# Concerns with stressed input tests in Annex 120G 8023ck\_D1p3

*John Calvin, Hadrien Louchet, Varun Garg*

# IEEE 802.3ck Receiver Input Test First Results

## STRESSED HOST INPUT, NEAR-END CALIBRATION

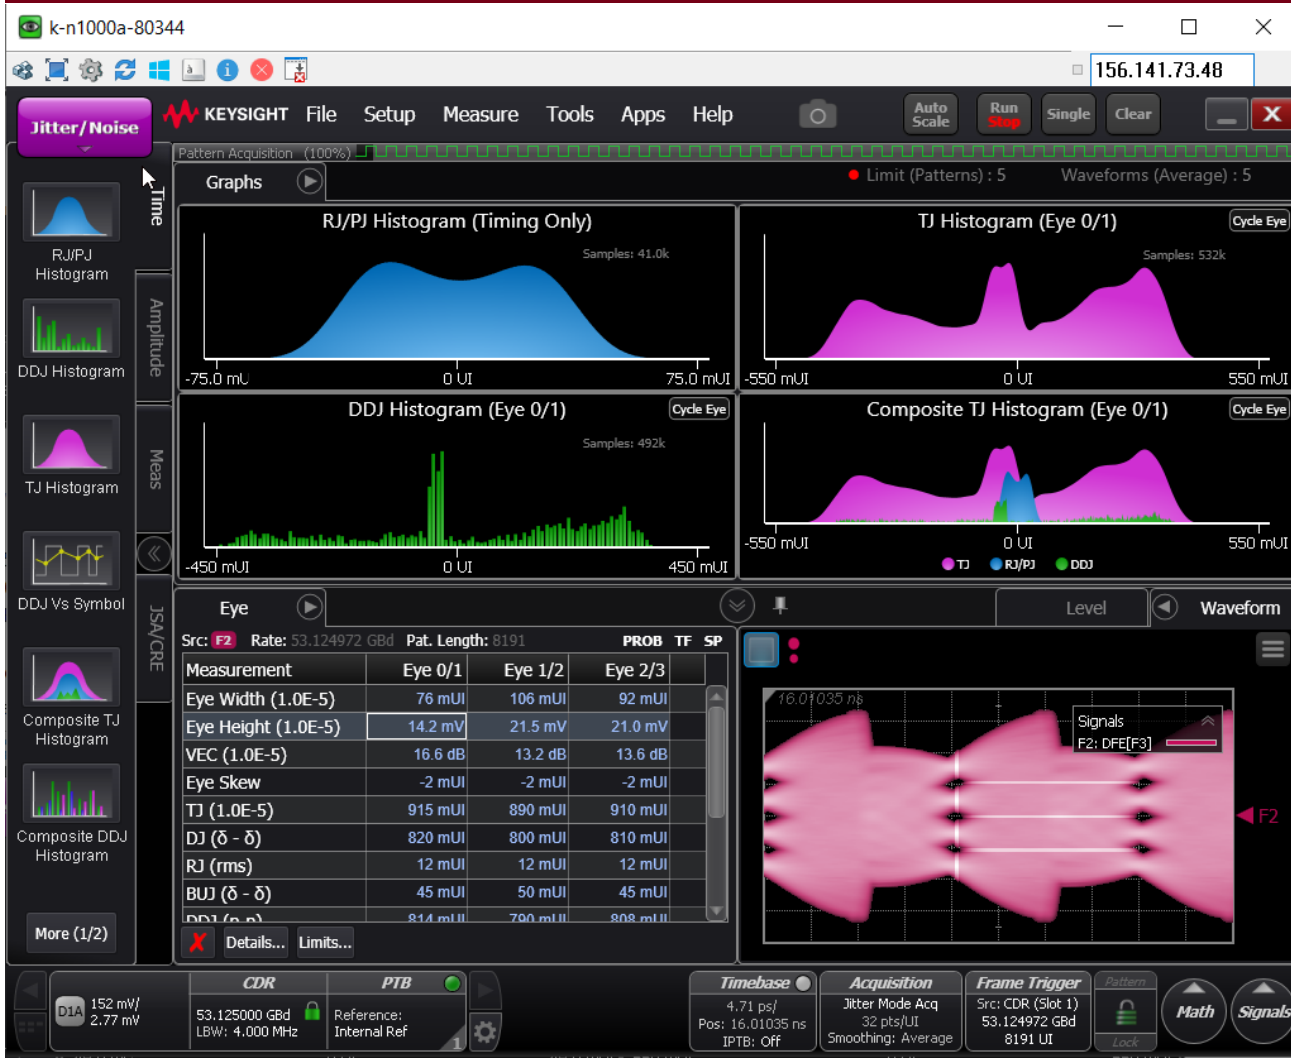
- Eye Height: 24 mV
- Eye Width: 190 mUI
- VEC: **8.30 dB > 7.5dB**

- Mismatched with standard requirements even though channel & Tx are compliant
- Injected Sinusoidal Jitter affect
  - Eye Width (~50mUI reduction)
  - VEC (from 1.5-4dB degradation observed depending on channel)

- perform simulation with this same test channel to compare results to empirical data.
- Host stressed input VEC changed from 7.5dB to 9.5dB to allow acceptable margin.
